August 20, 2008

Subject: Responses to Request for Additional Information (RAI) on the Amendment Application for CoC No. 9225 for the NAC-LWT Cask to Incorporate PWR Mixed-Oxide (MOX) Fuel Rods as Authorized Contents (TAC L24181)

Docket No. 71-9225

Figure 5-4.1 VISED Sketch of Discrete Pin Model

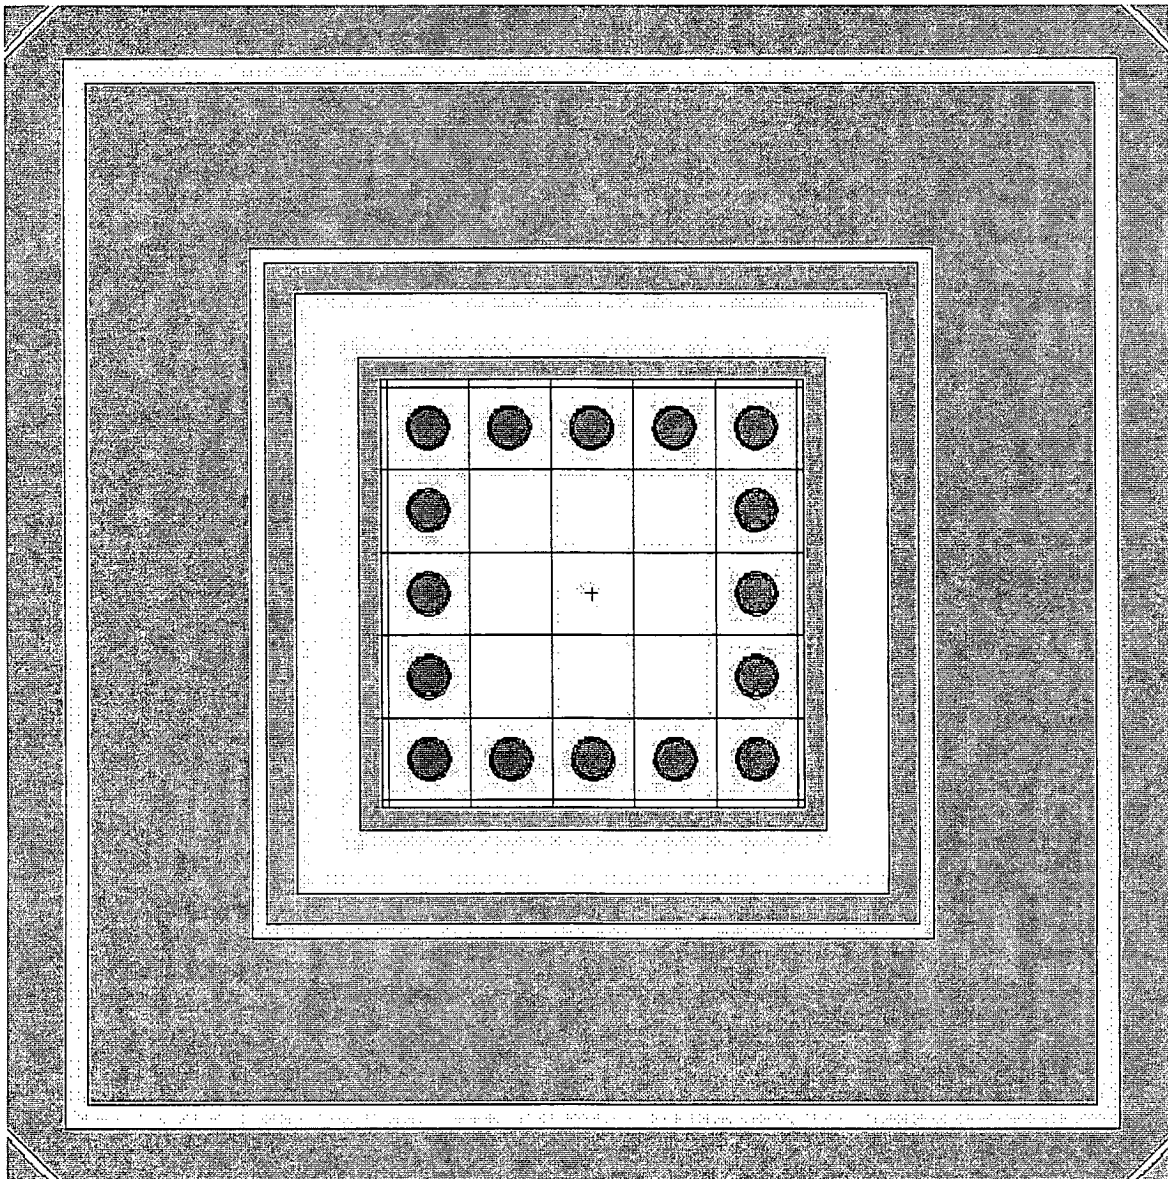
On page 5.3.18-3 of the SAR, the applicant states: "The combination of 16 fuel rods, either UO₂ or MOX fissile material based, are loaded into a 5 × 5 tube array insert constructed from stainless steel. ... The 16 rods are homogenized within the cross sectional area of the canister spacer." It is not clear, however, how the rods with different material compositions are homogenized. The staff's review of the sample input file, Figure 5.3.18-5, "Sample MCNP Input File for PWR MOX Fuel (Response Method Benchmark Case)" found that the composition of material with material ID card 1 is for pure UO₂ fuel rather than MOX fuel as the title of the figure indicates. It is not clear which model produced the results presented in Table 5.3.18-14 and Table 5.3.18-15.

To address concern that an exterior (outer layer) placement of 16 rods may produce higher dose rates, a revised shielding model explicitly placing the 16 minimum fuel mass fuel rods in the outer insert slot locations is evaluated. A VISED sketch of the revised cask internal model is shown in Figure 5-4.1. As shown in Table 5-4.1, for a sample 80 GWd/MTHM, 90-day cooled source, the discrete model produces lower dose rates than the homogenized source model. Reduced dose rates are the result of the high-density fuel rod actually providing more shielding for the now-compacted source region than the homogenized source. The SAR analysis model description in Section 5.3.18.2 and results in Section 5.3.18.3 are revised to include the additional model description and dose comparison.

Figure 5-6.1 Comparison of Direct Solution and Response Function Results at Cask Surface for Normal Conditions Model for Discrete Rod Mixed Loading of 8 UO₂ Rods and 8 WG Rods

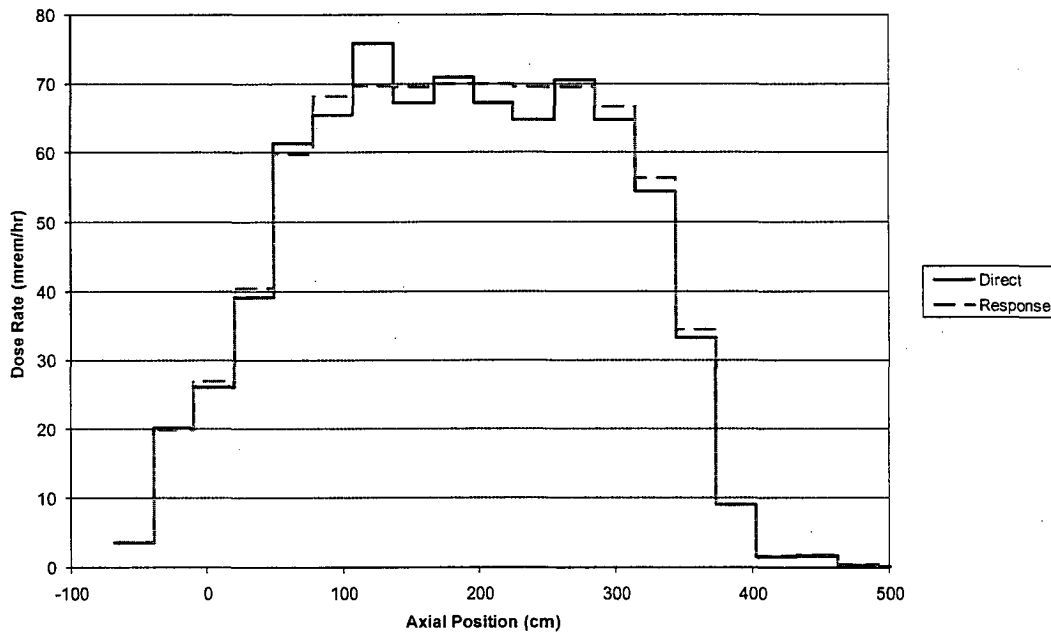
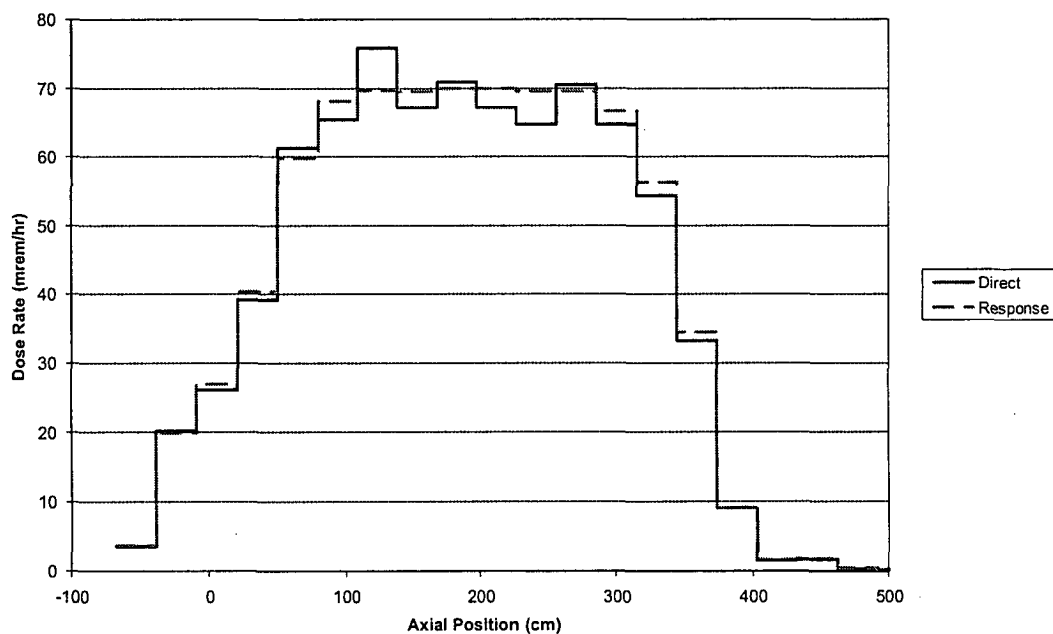
On page 5.3.18-4 of the SAR, the applicant states: "A sample input file is provided in Figure 5.3.18-5. The sample input provides a complete source description used in the response function benchmark analyses." As this approach completely decoupled the dependence of the particle transport to the material composition of the media that the particles traverse and interact with, the reliability and the accuracy of this approach can be assessed only on a case-by-case basis. It is especially true for MOX fuel because of the large cross sections of the fission, (n, 2n), (gamma, n), (n, gamma), and (n, alpha) reactions and the secondary radiation generated by these nuclear reactions.

are based on the discrete fuel rod model to allow mixed fuel to be explicitly accounted for. Results of the comparisons are shown in Figures 5-6.1, 5-6.2 and 5-6.3, and demonstrate that the results of the response and direct solutions are equivalent, independent of the source modeling employed (i.e., discrete fuel rods or homogenized). Differences between response method and direct calculation results are associated with significantly higher statistical uncertainties produced by the direct calculation approach.
